SB TMG 651-1003 P1

SERVICE BULLETIN

Subject: Turbocharger Clamp Replacement

Type affected: All Piper PA 28 with TAE 125-01 and TAE 125-02-99

Figure 1

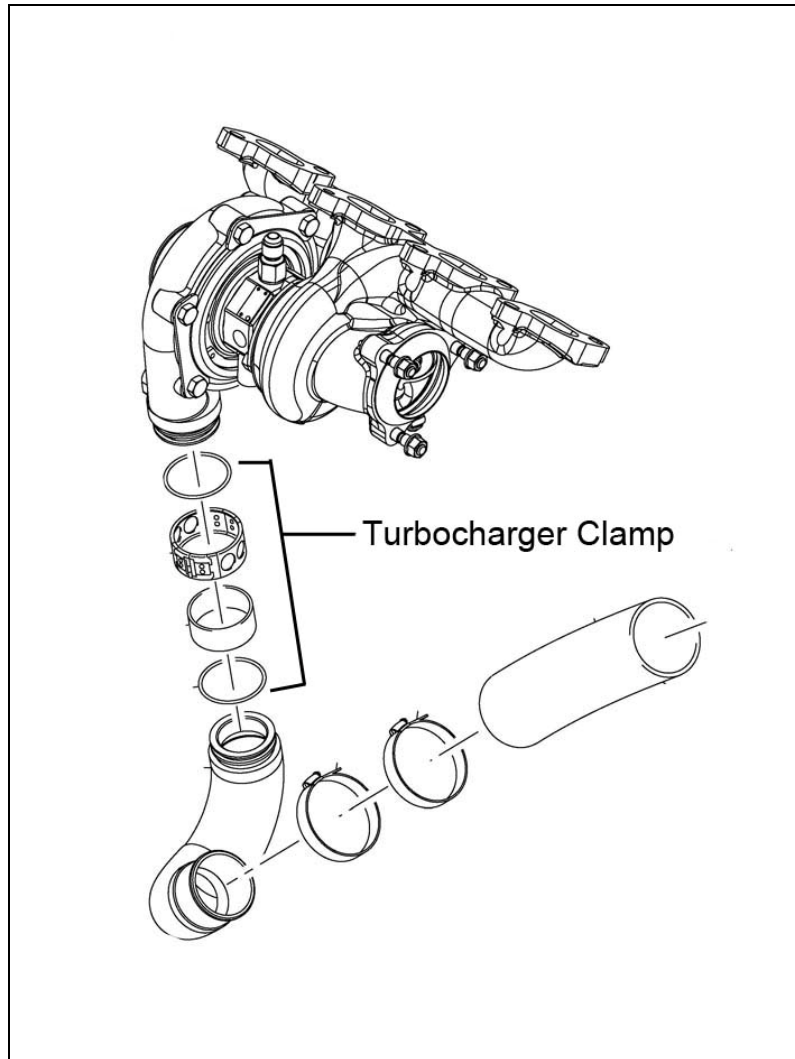
1. Remove the turbocharger clamp:

- Make sure that the engine is cold before starting work at the engine.
- Remove the turbocharger clamp including the inner ring and the O-rings.
- **CAUTION:** When opening the turbocharger system, pay special attention to prevent contamination.

Figure 2

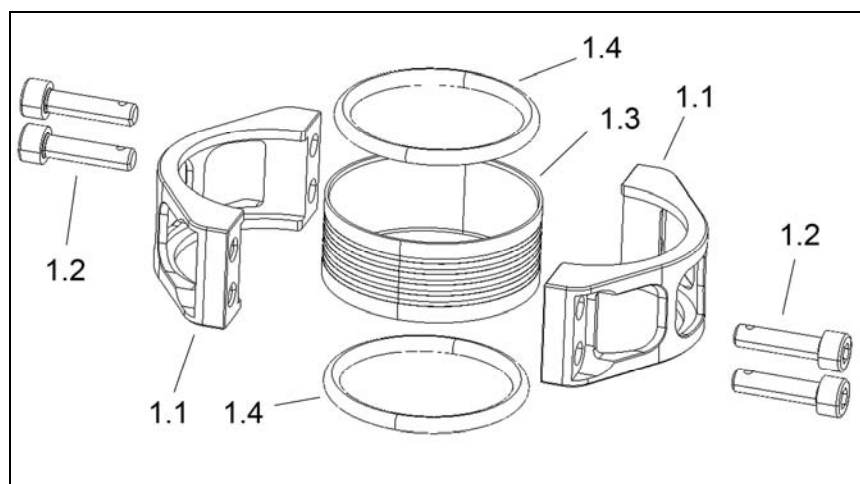
- Attach one O-ring (item 1.4) to the notch at the flange of the turbocharger.
- Attach the other O-ring (item 1.4) to the notch at the turbo pipe.
- ◆ Note: Use lubricant for installation of the O-rings and the coupling. Check correct fit.
- Connect the turbo pipe to the turbocharger and secure with the coupling (item 1.3) and the two half shells (item 1.1) using four screws (item 1.2). See Figure 2.

Tightening Torque: 8Nm

- Check if the clamp can be moved easily.
- ◆ Note: Tension at the clamp or misalignment of piping can lead to deformation or damage.
- Secure the screws with safety wire. See Figure 3.
